## HISTORIC AND DESIGN REVIEW COMMISSION

June 21, 2017

**HDRC CASE NO:** 2017-289  
**ADDRESS:** 815 N HACKBERRY ST  
**LEGAL DESCRIPTION:** NCB 538 BLK 22 LOT N 66.3 FT OF 14 & N 66.3 FT OF E 9.52 FT OF 13  
**ZONING:** R-5 H  
**CITY COUNCIL DIST.:** 2  
**DISTRICT:** Dignowity Hill Historic District  
**APPLICANT:** Eduardo Martinez  
**OWNER:** Eduardo Martinez  
**TYPE OF WORK:** Porch column replacement  
**REQUEST:**

The applicant is requesting a Certificate of Appropriateness for approval to replace the existing front porch columns which feature framed fretwork with new front porch columns that capital molding and trim consistent with the Folk Victorian style.

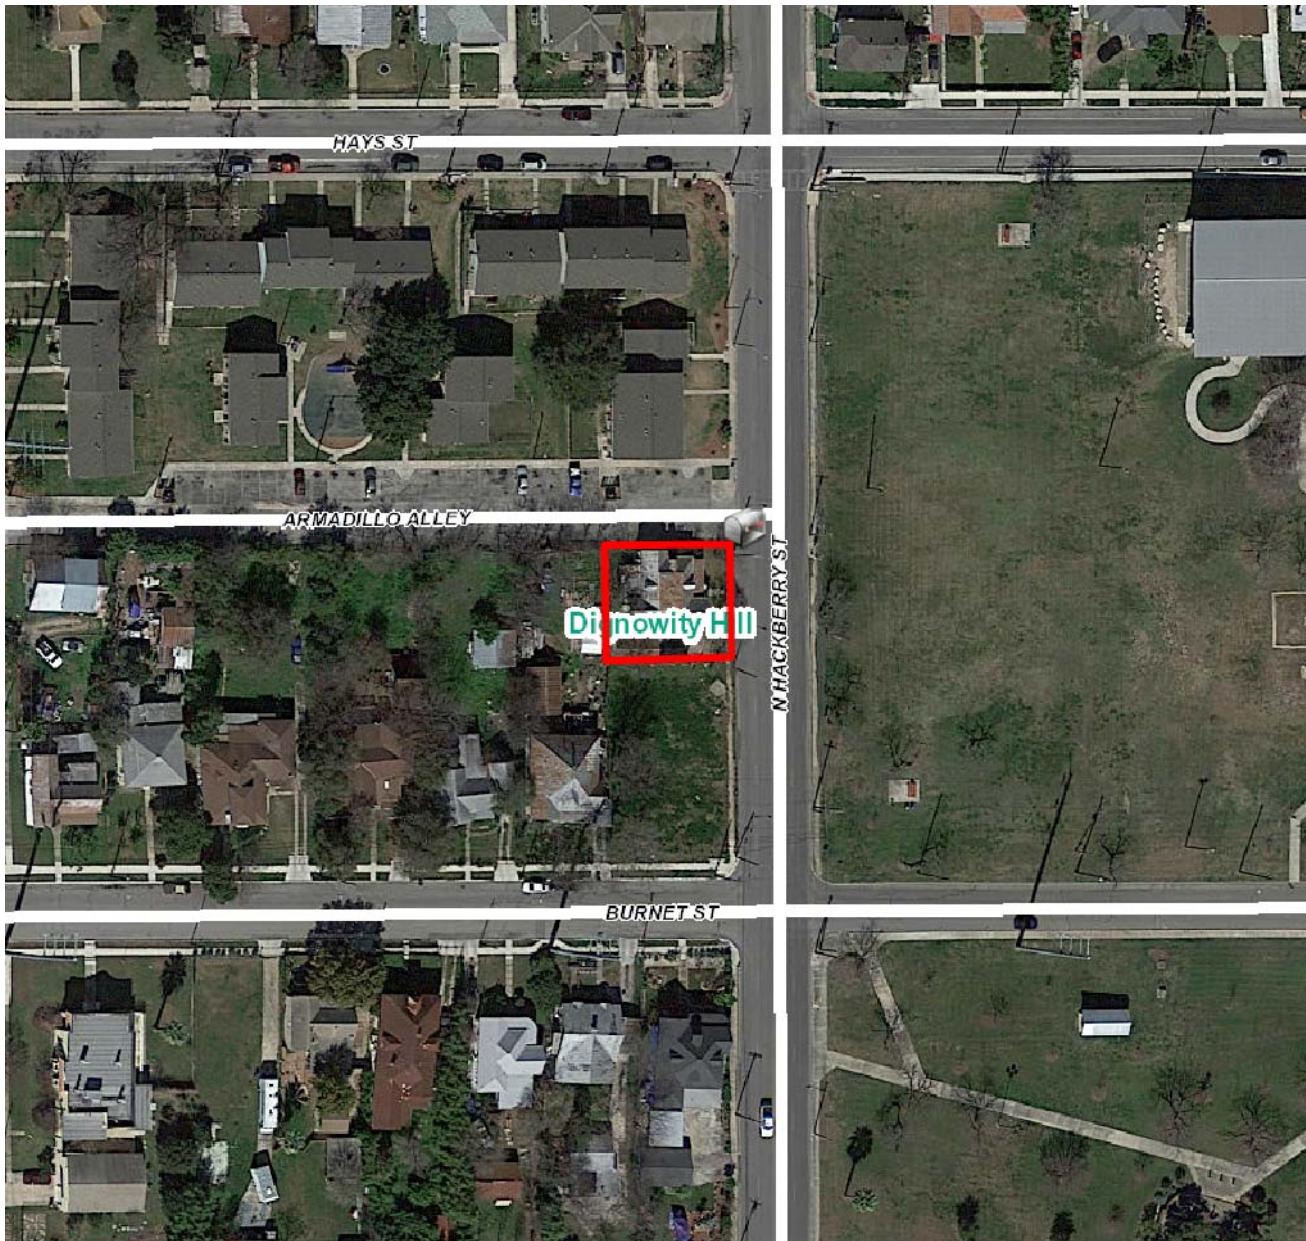
- a. The structure at 815 N Hackberry was constructed circa 1920 and features Folk Victorian architectural elements including brackets under the roof eaves, spindle or fretwork and both a front and side gabled roof. This structure first appears on the 1951 Sanborn map. A previous structure with a much smaller footprint was located at this location on the 1912 Sanborn map. The applicant has received Administrative Approval for the repair of damaged porch decking/flooring and the re-installation of missing porch railings to match the existing.
- b. PORCH COLUMNS – The existing porch columns feature square posts with framed fretwork on each side of the capital. The general placement of these porch columns is generally consistent with the Folk Victorian style; however, the staff finds the existing columns to feature detailing and ornamentation that does not appear to be

original. The applicant has proposed to install new front porch columns that are to feature simple column molding and trim, consistent with similar Folk Victorian structures. Staff finds the proposed columns to be appropriate and consistent with the Guidelines 7.B.

Staff recommends approval based on finding b with the stipulation that the applicant submit a column detail to staff for approval prior to receiving a Certificate of Appropriateness.
